Contract #: 04-0120F4Cty: SF/ALA Rte: 80 PM: 13.2/13.9File #: 69.25B**QUALITY ASSURANCE -- NON-CONFORMANCE REPORT****Location:** Changxing Island**Report No:** NCR-000370**Prime Contractor:** American Bridge/Fluor Enterprises, a JV**Date:** 28-Jun-2009**Submitting Contractor:** Zhenhua Port Machinery Company, Ltd (ZPMC), Changxing Island**NCR #:** ZPMC-0344**Type of problem:****Welding****Concrete****Other****Welding****Curing****Procedural****Bridge No:** 34-0006**Joint fit-up****Coating****Other****Component:** OBG 1AAE & 1AAW**Procedural****Procedural****Description:****Reference Description:** End Plates**Description of Non-Conformance:**

Job Name: SAS Superstructure

Subject: NCR No. ZPMC-0344

Heat Straightening Report (HSR)

简图 Sketch

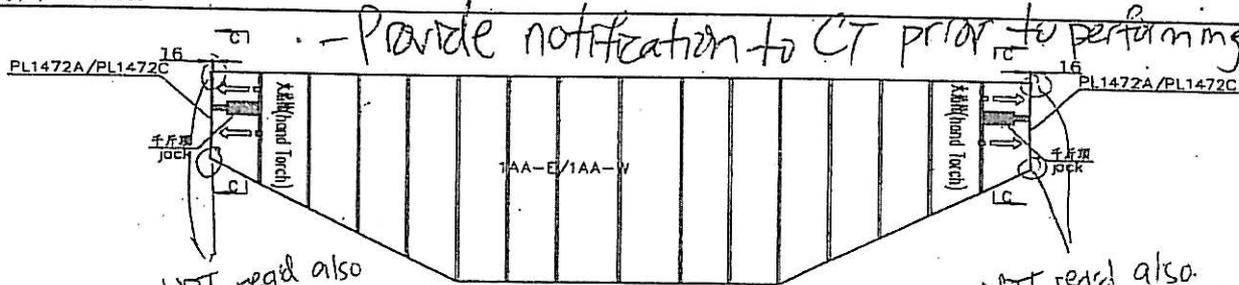
Jacking shall not be used to plastically deform the flange. The Jack shall only be used as a fixture.

After finishing heat straightening, the weld of the treat area shall perform NDT according to the approved shop drawing. 不能使用千斤顶进行塑性变形。千斤顶只能用作固定装置，校火后需按照图纸上的要求对热影响区域进行 NDT 检测。

注: 最大变形量约16mm, 校火厚度20~100mm.
NOTE: the max deformation is about 16mm, heat straightening the width is 20~100mm.-E.T.
2009.6.26
